ADDENDUM #2

January 9, 2025

East Calais Post Office & Moscow Woods Road Gully East, Vermont

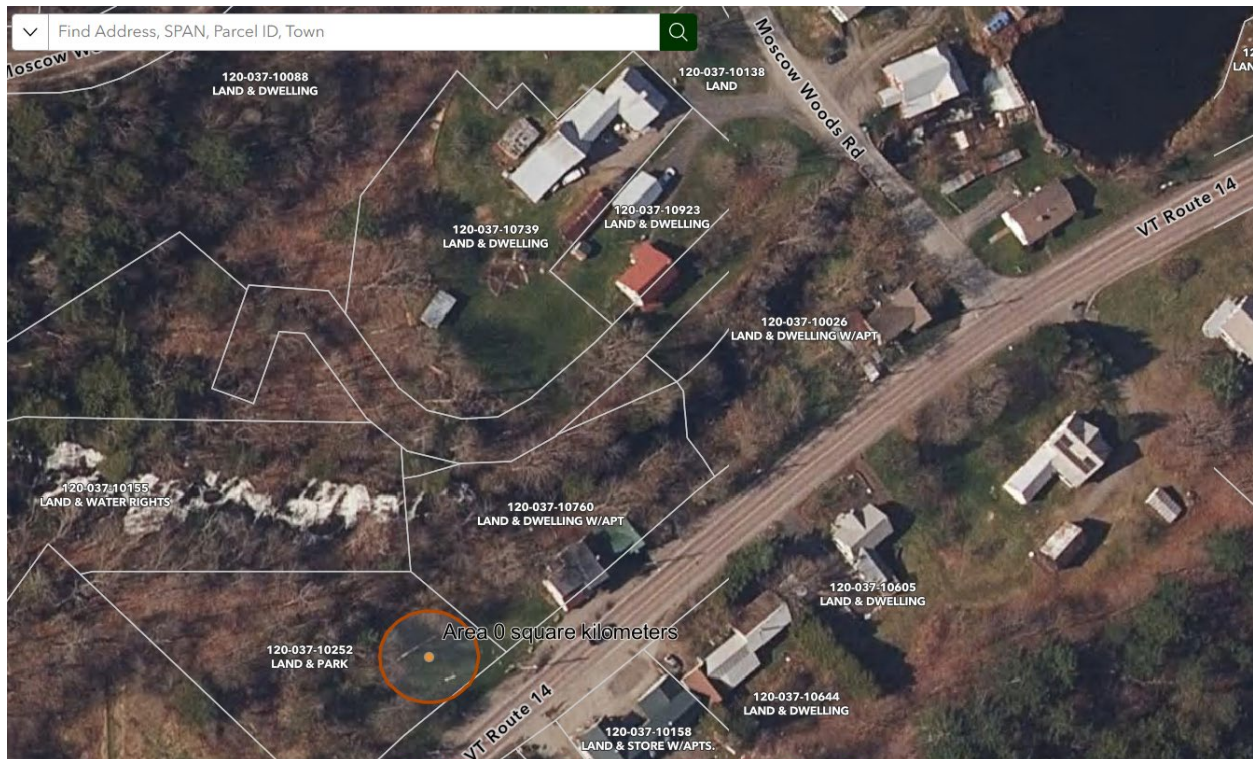
Q. Are there other potential staging areas?

A. The Rec field located north on Route 14 is not available, but the contractor can use the park directly across Route 14 from the East Calais General Store. The general area is circled on the below map and shown in the below photo. If used, the Contractor is responsible for restoration of the area to pre-construction conditions. The tanks and pump station should not be disturbed (located on the northeast portion of the property).
